Warringah Freeway Upgrade  
Transport for NSW  
Locked Bag 928,  
North Sydney NSW 2059

**Re: Cycling and Walking in North Sydney and beyond**

Thank you for the opportunity to comment on the Active Transport Network Review (ATNR) for North Sydney and surrounds.

Figure 5: Alterations proposed to Berry St by the WHT project will prevent the improvements to walking, cycling and landscaping that are key to the successful operation of the Metro and other projects (Source: Acciona)

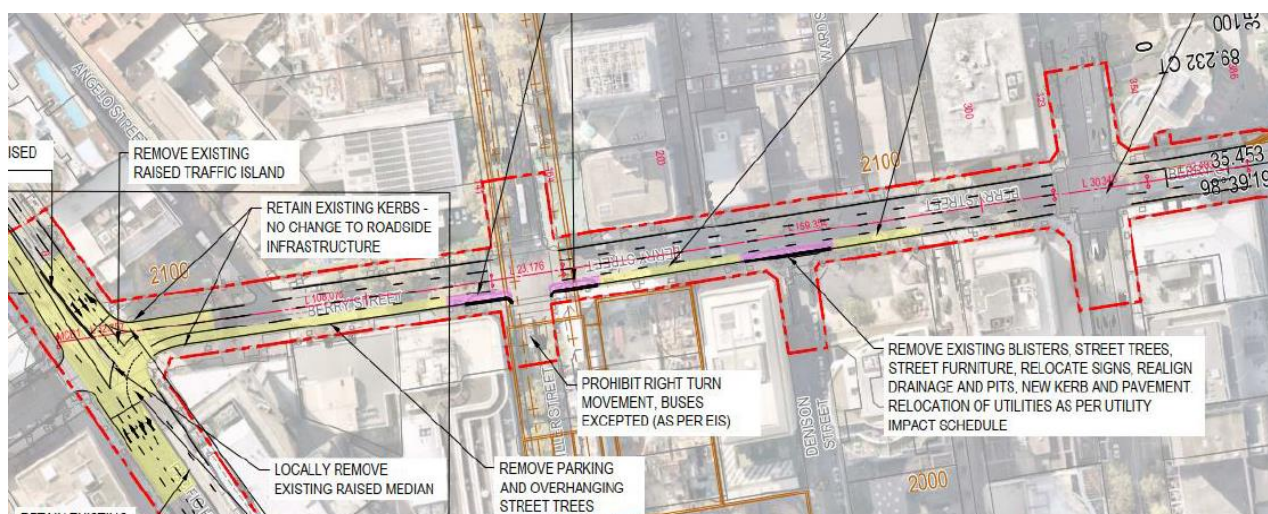
Note that we have learnt of Western Harbour Tunnel (WHT) plans to remove parking, kerb extensions and trees on Berry Street to create 4 clear vehicle lanes (Figure 5). This does not align with other proposals to reduce the current function of Berry St as a key access route to the freeway. A section of separated cycleway on Berry Street is required to deliver North Sydney CBD East route!

Figure 7: Plan of the Cammeray area once the WHT is complete. Is this an accurate representation of what is proposed? (Source: Acciona)

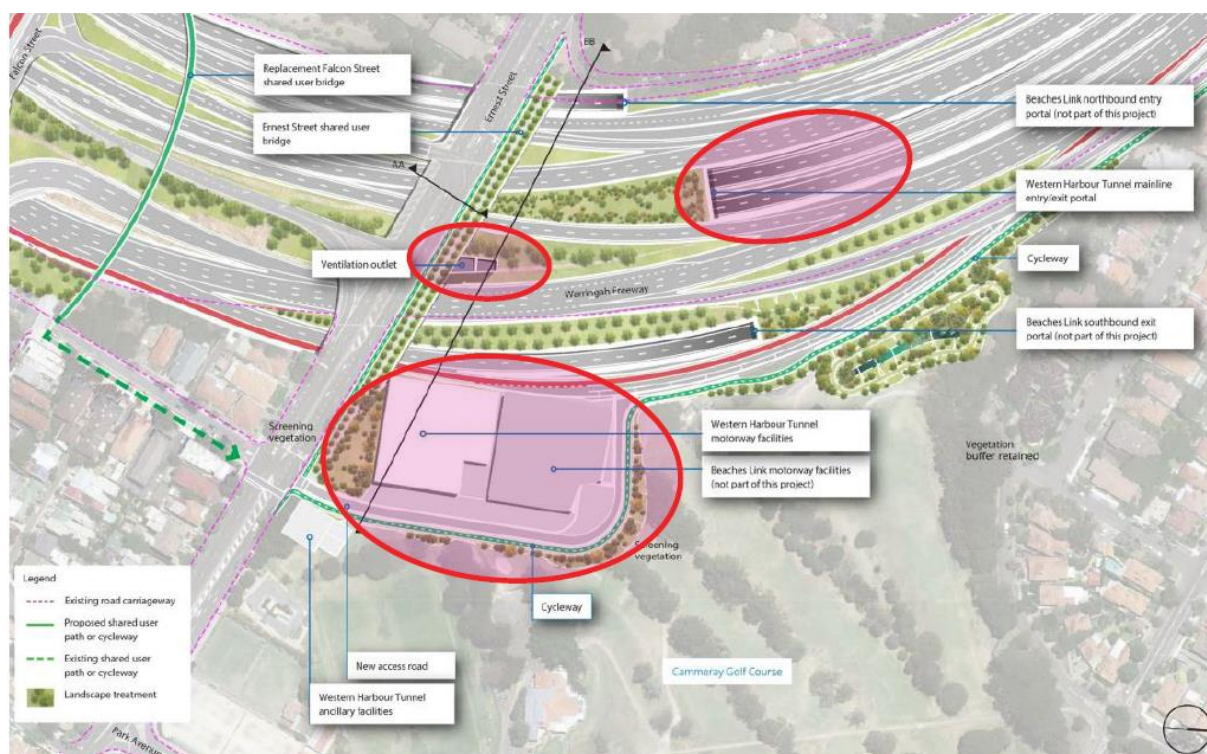
- Note that there is another worrying example of conflicting documentation about a cycleway running along the eastern edge of the motorway corridor from Ernest St to Miller Street. The WHT documents include a plan of the Cammeray precinct with a cycleway running behind the motorway facilities and then along the edge of the freeway (Figure 7). The Active Transport Network Review map shows this route as a 'project in development'. Until the end of June, the map on the online WFU portal included the statement *'We are building a dedicated cycleway between Miller and Falcon Streets at Cammeray to improve safety and journey times for cyclists'*. This promise is no longer visible and there is no other no other indication that a cycleway will emerge from the rubble in this location. It is not mentioned at all in the PDLP.

This cycleway would provide important connectivity and replace the well-used shoulder lane removed to create the construction zone at Cammeray. It is vital for all stakeholders to clarify what is planned.
